# Access Compliance Report

## Public Rights-of-Way

Intersection ID: 50588	Main Street: BENDING_BRANCH_RD	Cross Street: DOWNY_BIRCH_RD	Location: NW
ADA ID: 8F525BC01238	Ramp Type: Perpendicular	Initial Pass/Fail: Fail	Overall Compliance: No
		Severity Score: 8.75

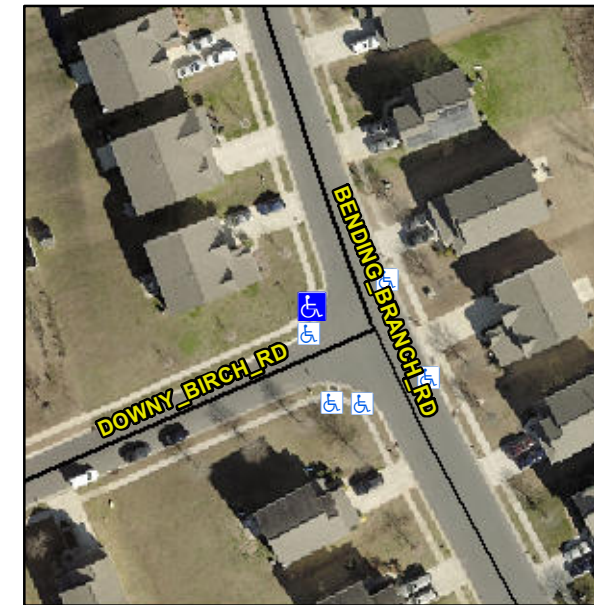
**Not Found, R304.5.1**

Compliance	Description	Data	Compliance	Description	Data
N/A	Ramp Length (in)	47.5	Yes	Ramp Slope (%)	6.6
No	Ramp Width (in)	47.5	Yes	Ramp XSlope (%)	1.9
N/A	Flare Type LT	N/A	N/A	Flare Type RT	N/A
N/A	Flare Slope LT (%)	N/A	N/A	Flare Slope RT (%)	N/A
N/A	Flare Traversable LT?	N/A	N/A	Flare Traversable RT?	N/A
N/A	Landing Length (in)	N/A	N/A	DWS Provided?	N/A
N/A	Landing Width (in)	N/A	N/A	DWS Contrast?	N/A
N/A	Landing Slope (%)	N/A	N/A	DWS Length (in)	N/A
N/A	Landing X Slope (%)	N/A	N/A	DWS Full Width?	N/A
N/A	Landing Curb? (Y/N)	N/A	N/A	DWS Offset (in)	N/A
N/A	Shared Landing?	N/A			
N/A	Gutter Ponding?	N/A	N/A	Gutter Slope (%)	N/A
N/A	Gutter Lip Ht (in)	N/A	N/A	Gutter X Slope (%)	N/A
N/A	Painted X Walk1?	No	N/A	Painted X Walk2?	N/A
	X Walk 1 Direction	To E		X Walk 2 Direction	N/A
N/A	X Walk 1 Width (in)	N/A	N/A	X Walk 2 Width (in)	N/A
	X Walk 1 Slope (%)	2.6		X Walk 2 Slope (%)	N/A
	X Walk 1 X Slope (%)	2.4		X Walk 2 X Slope (%)	N/A

**Remove & Replace Entire Ramp.**
